REFERENCE: **Falling Debris Hazard Mitigation Recommendation**
 Dana Hills High School
 33333 Golden Lantern
 Dana Point, CA 92629
 KNA No. 371.002

ROOF FRAMING PLAN
5'-1'-0"

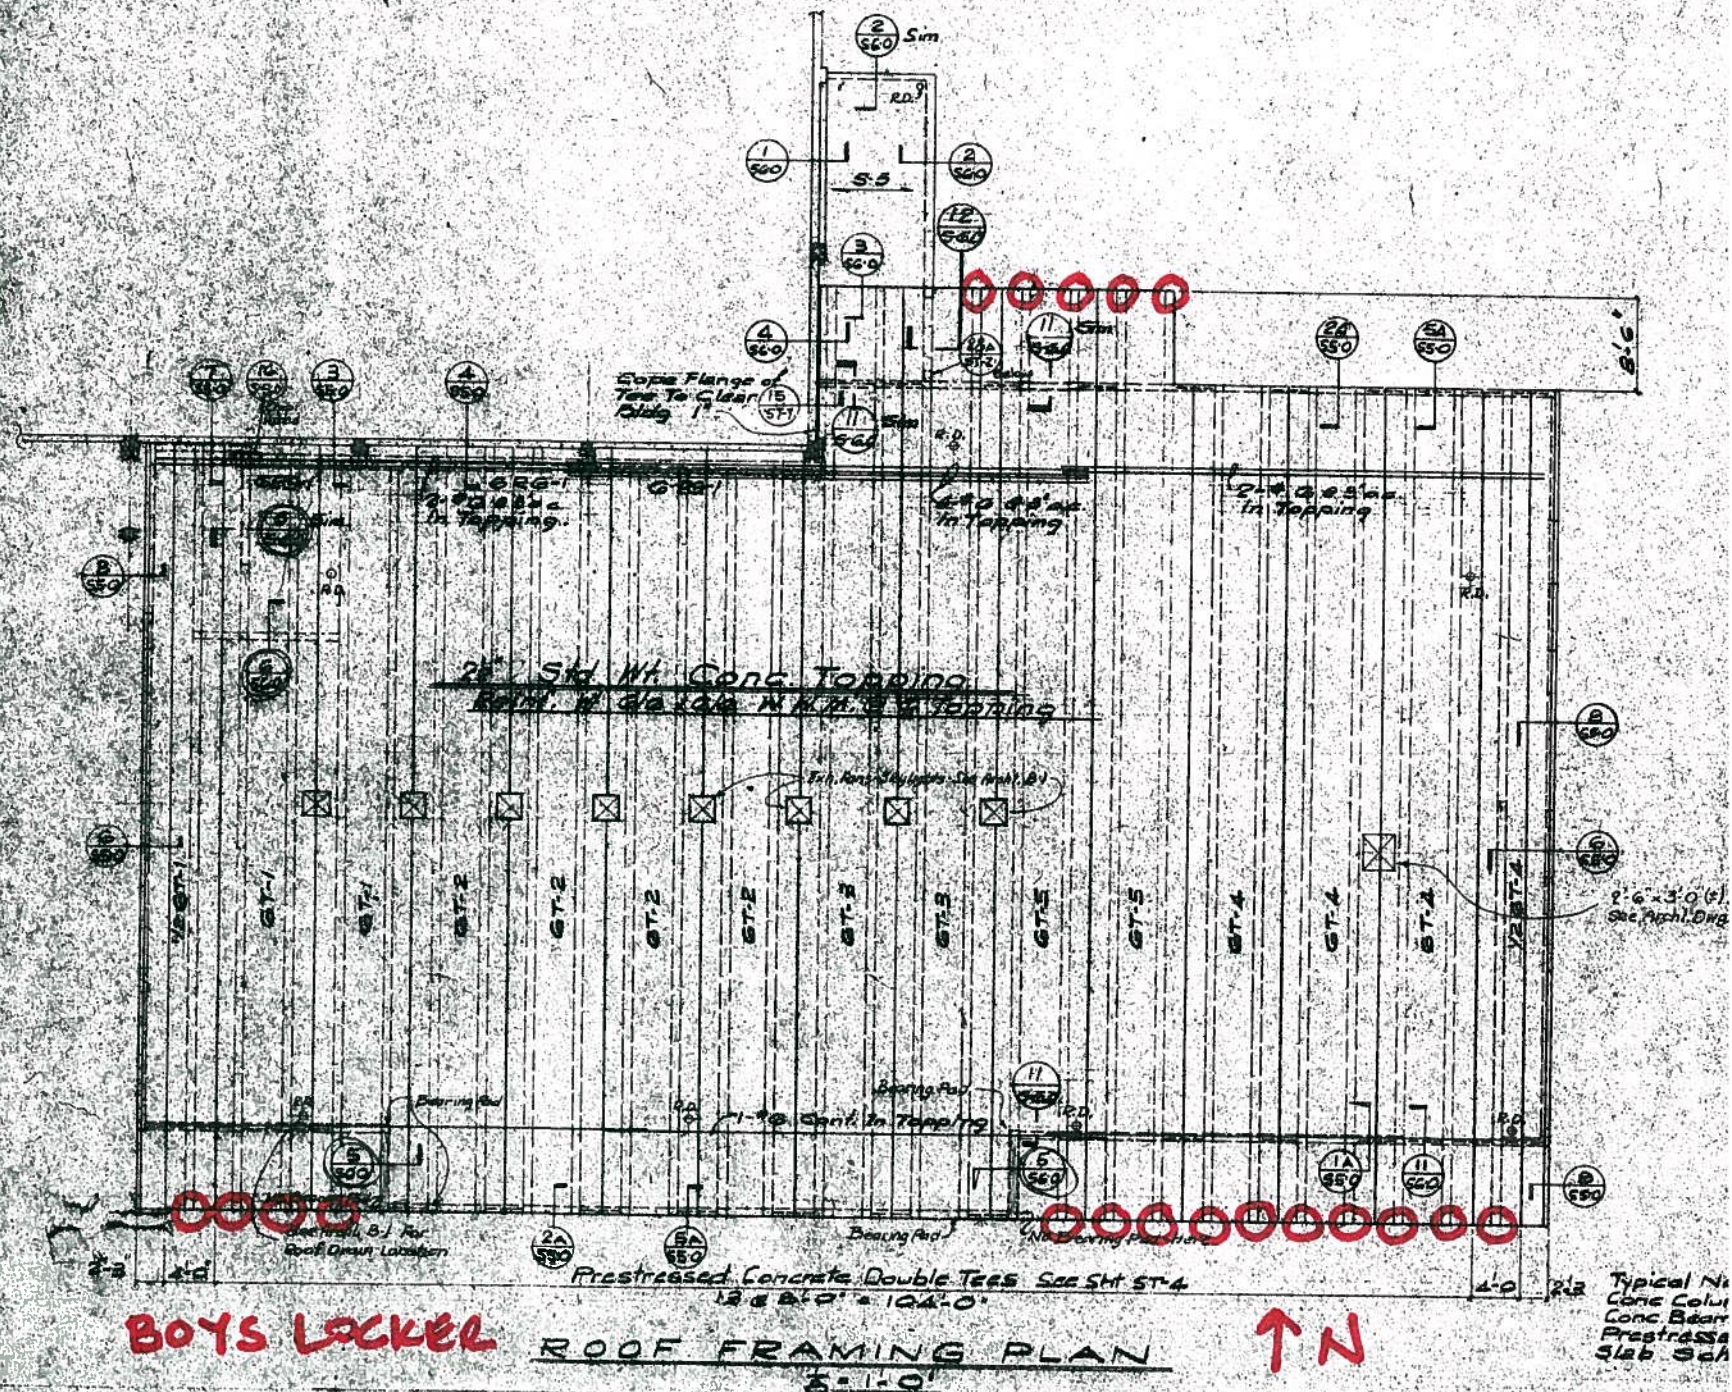
The tee beam ends for the roofs over the Gymnasium, Student Mall, and Theater all occur over adjacent low roofs. Consequently the current state of deterioration does not pose any threat of falling debris on students and staff from the tee beam ends in those areas. The tee beam ends for the roofs over the Boys' and Girls' Shower and Locker areas occur over exits, walkways and path of travel. We have identified areas on the attached markup of the existing structural roof framing plans where beam ends pose a threat of falling debris on students and staff. Areas of concern are circled in red.

We recommend that the loose material at the ends of all tee beams identified on the attached plans be knocked off by mechanical means such that only sound material remains. This is the most straightforward and full proof approach to protecting students and staff from the risks of falling debris.
